Wollongong Local Planning Panel Assessment Report | 13 February 2018

WLPP No.	Item No. 2
DA No.	DA-2018/1316
Proposal	Demolition of existing structures and construction of a residential flat building comprising 16 apartments and two (2) levels of basement parking
Property	2 Blacket Street NORTH WOLLONGONG
Applicant	Quill Holdings Pty Ltd
Responsible Team	Development Assessment and Certification – City Centre Team (TW)

ASSESSMENT REPORT AND RECOMMENDATION

Figure 2: Extract of applicant’s SEE identifying area of building height non-compliance.

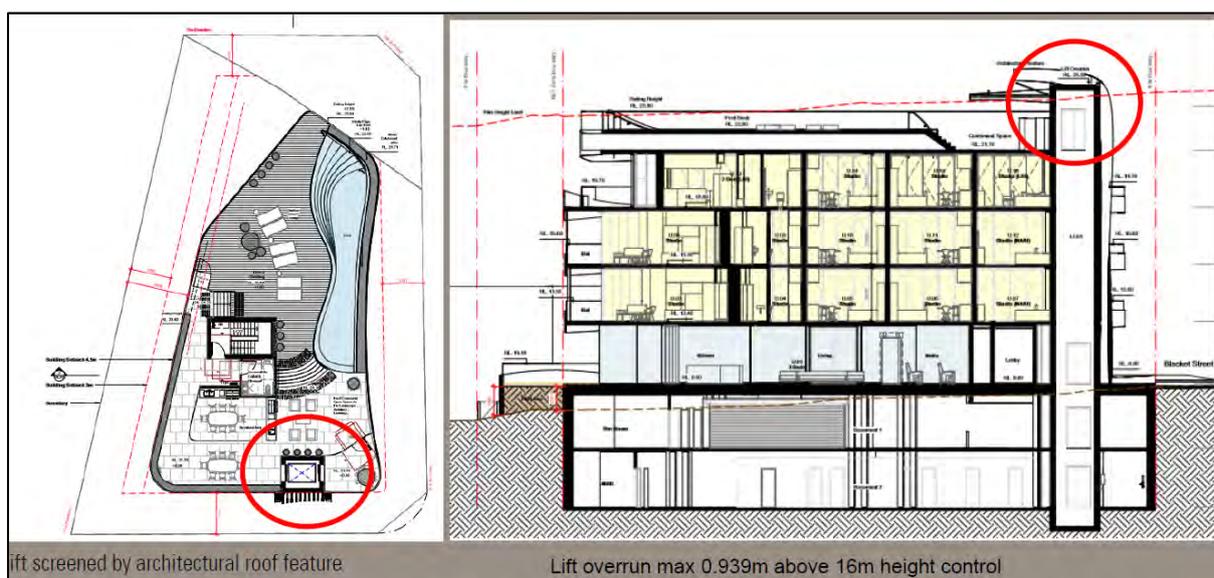
The proposal does not comply with the 16m maximum height limit. The applicant has identified the uppermost height of the building as being 16.939m measured to the top of the lift overrun at the southern end of the building.

A rooftop form comprising an awning suspended from an element projecting from the top of the lift overrun is proposed over part of the rooftop communal open space. The applicant contends that this element is an ‘architectural roof feature’ for the purposes of Clause 5.6 of Wollongong LEP 2009.

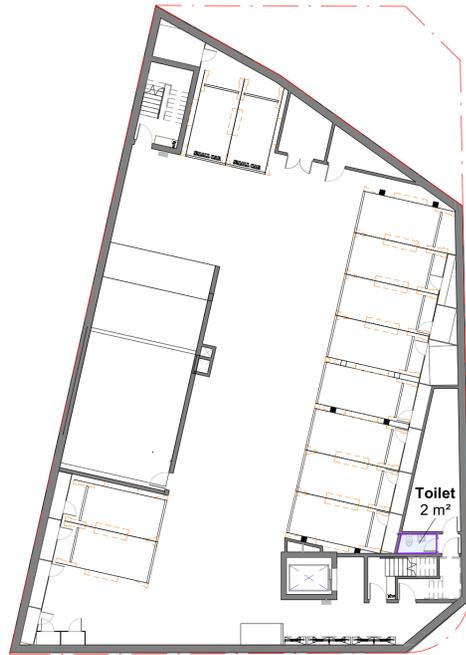
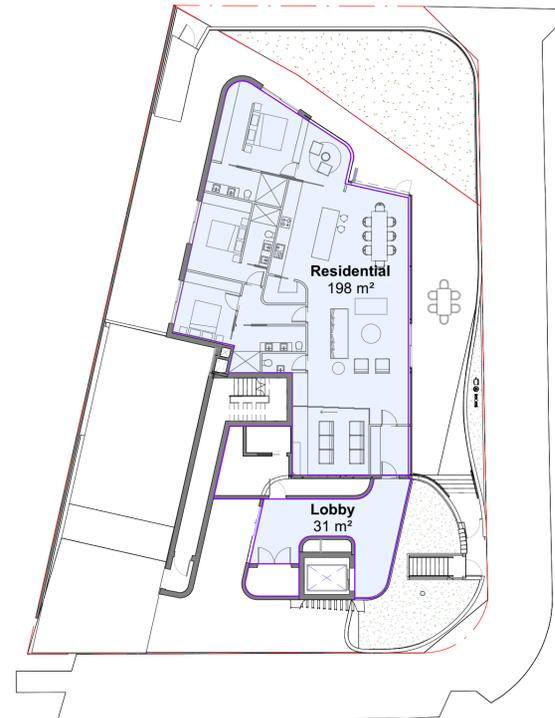
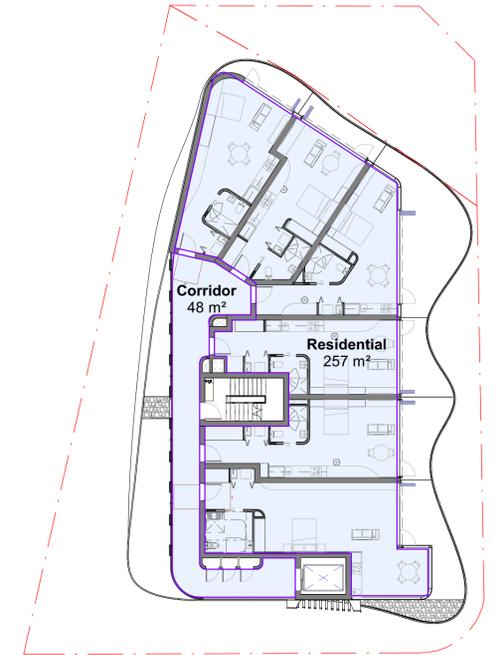
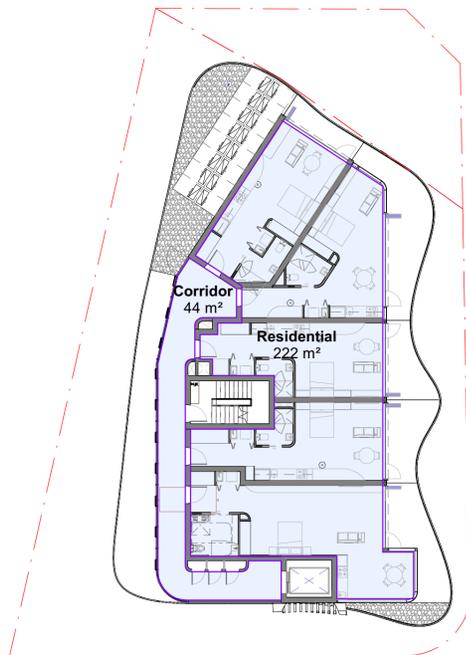
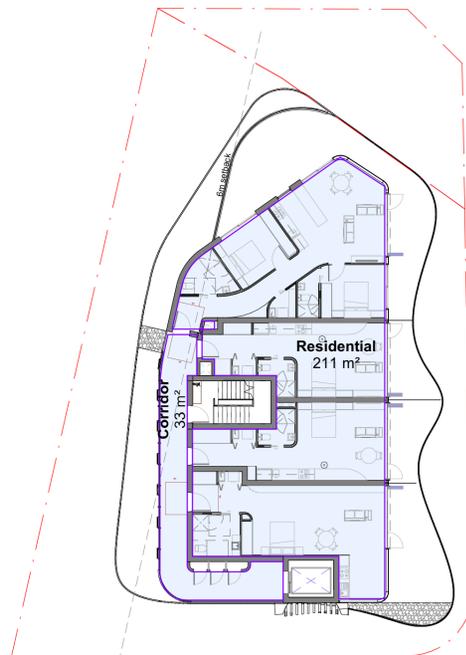
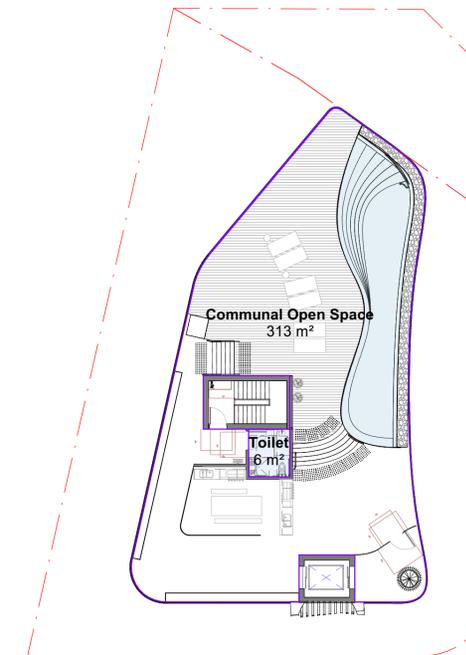
The applicant has provided gross floor area analysis plans and contends that the gross floor area of the building totals 1052.4sqm. However, the gross floor area analysis plans submitted by the applicant excludes certain areas within the building which are included in the definition of gross floor area provided by the Dictionary to Wollongong LEP 2009. These includes the ground floor level storage rooms adjacent to the lobby, the ground floor fire egress corridor, and the rooftop 'breakout area' which is enclosed plus the area of the three (3) surplus car spaces and access thereto. It is difficult to quantify the area of the access to the surplus car spaces. The combined additional area of these spaces (exclusive of the area of the access to the surplus car spaces) totals at least 93sqm. The inclusion of this additional area results in a floor space ratio of at least 1.63:1.

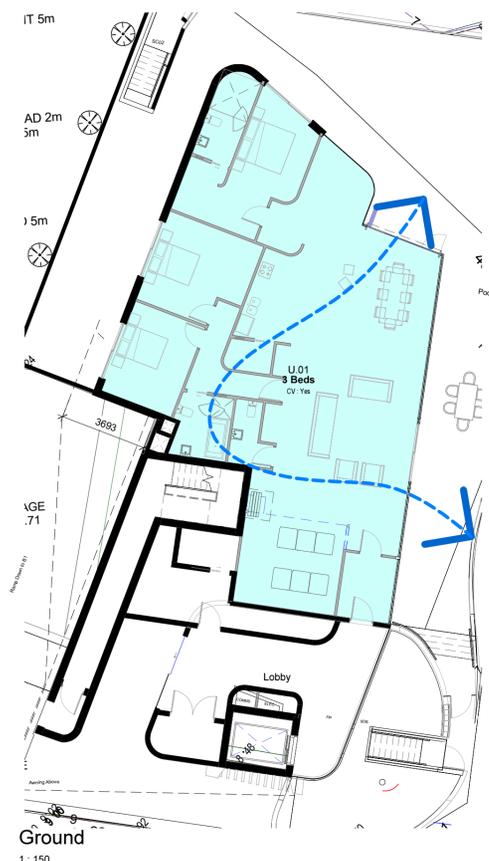
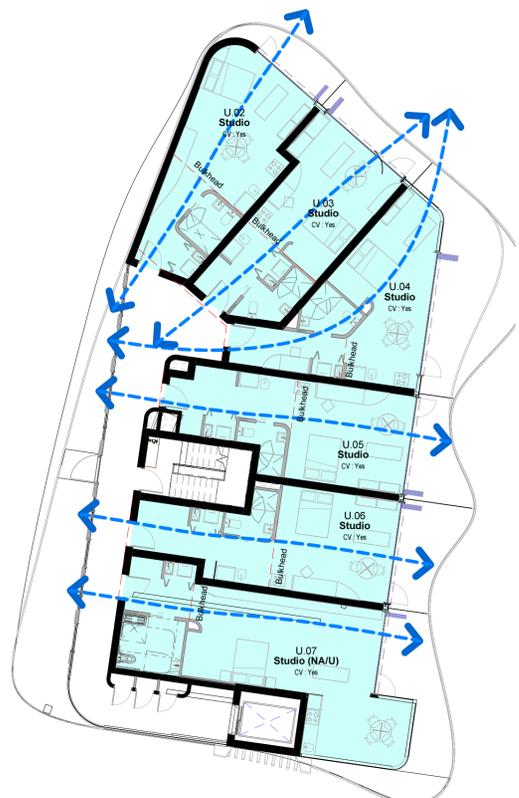
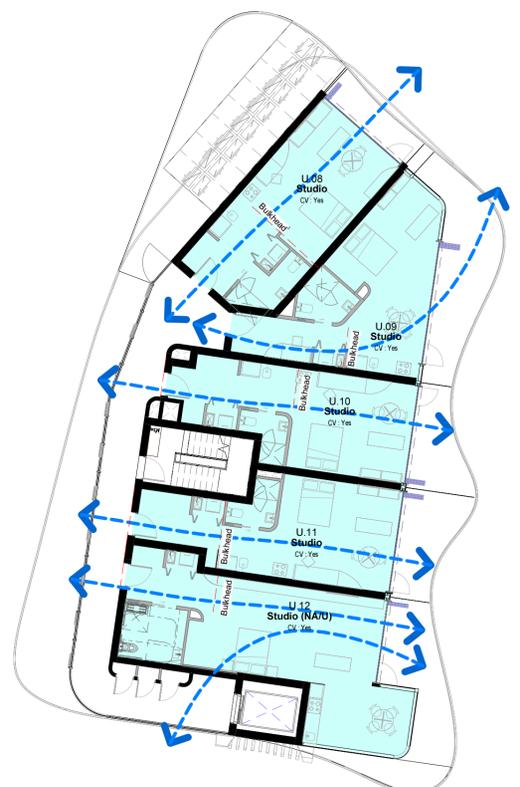
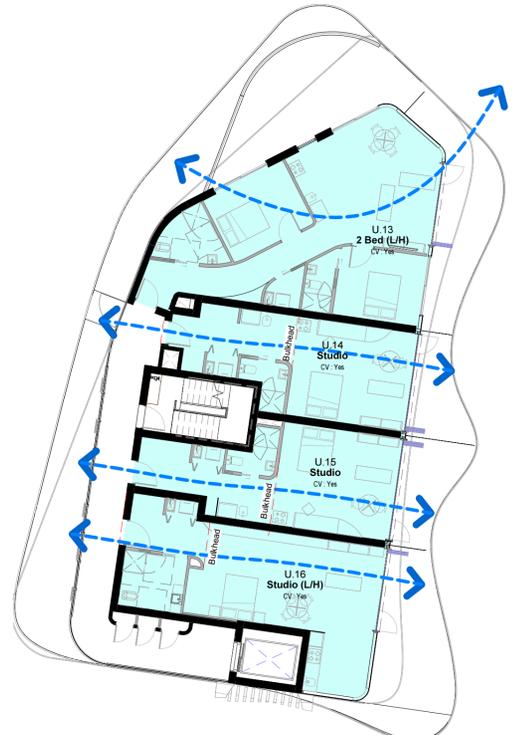
- 4B - Natural Ventilation – the design criteria for Objective 4B-3 in the ADG requires that at least 60% of apartments are naturally cross ventilated. Two units (12.5%) achieve cross ventilation, being Units 1 and 13. All other apartments rely on a plenum ventilation system to provide cross ventilation, the practicality and technical compliance of which is questioned given the design proposed. Further information is required to demonstrate compliance with Part 4B of the ADG in regards to suitability of the method of cross ventilation proposed. In the absence of this information, it is concluded that 87.5% of the apartments are not cross ventilated. Thermal comfort and internal amenity within these apartments will be adversely affected as a result. If it can be demonstrated that the plenum ventilation system proposed will provide for effective and compliant ventilation to the apartments, the system relies on openings to the western access corridor. These openings will compromise the internal acoustic privacy and amenity of the units via sound transmission to and from the corridor.

Figure 3-2 Section and roof plan showing minor exceedance of 16m height limit

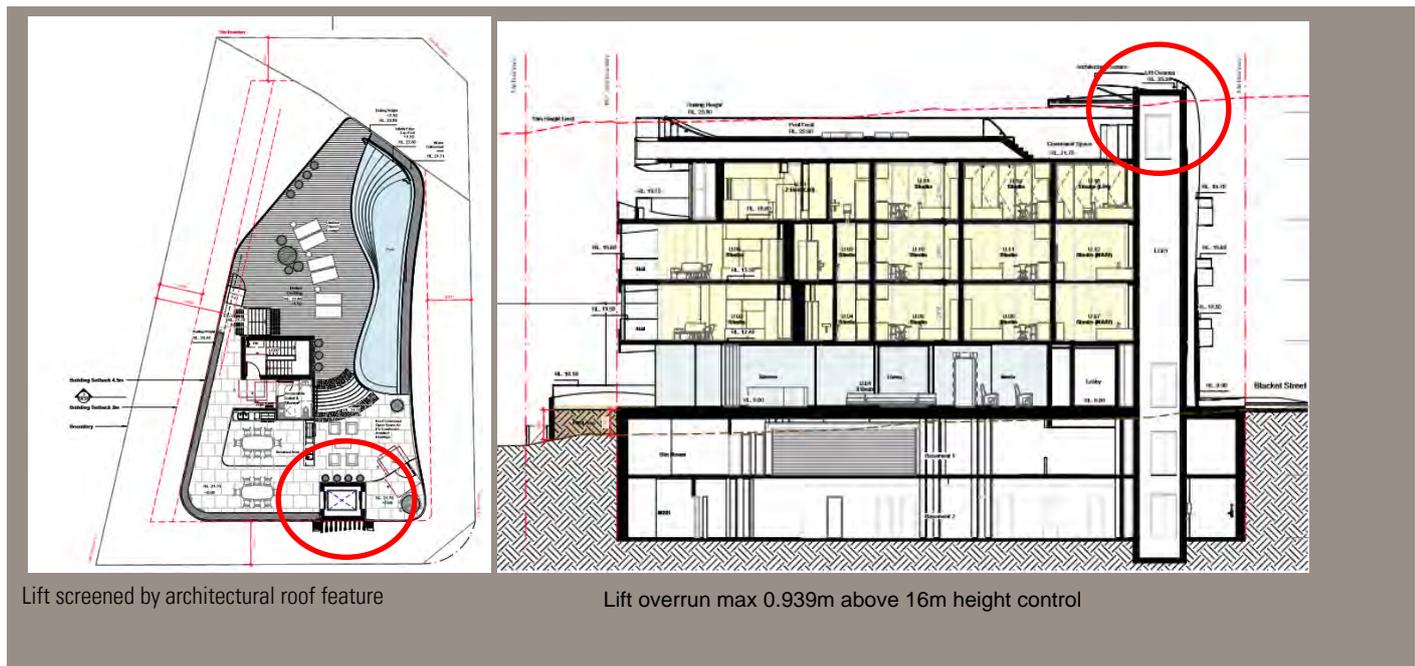
Clause 4.6 of the Wollongong LEP "Exceptions to development standards" provides that development consent may, subject to this clause, be granted for development even though the development would contravene a development standard imposed by this or any other environmental planning instrument, where certain matters are met. As noted above, the applicant has sought a departure in respect of building height which is discussed in the table below. A full copy of the exception request forms **Attachment 5**. The applicant contends that the entire building is under the 16m height plane and that the 'minor non-compliance of 0.939m' applies to the topmost portion of the lift overrun (refer to Figure 3 above). This is contrary to Council's view that the supposed 'architectural roof feature' does not comprise an 'architectural roof feature' for the purposes of Clause 5.6 and accordingly a part of this structure also exceeds the height limit. Council considers the maximum overall height of the building to be 17.777m.
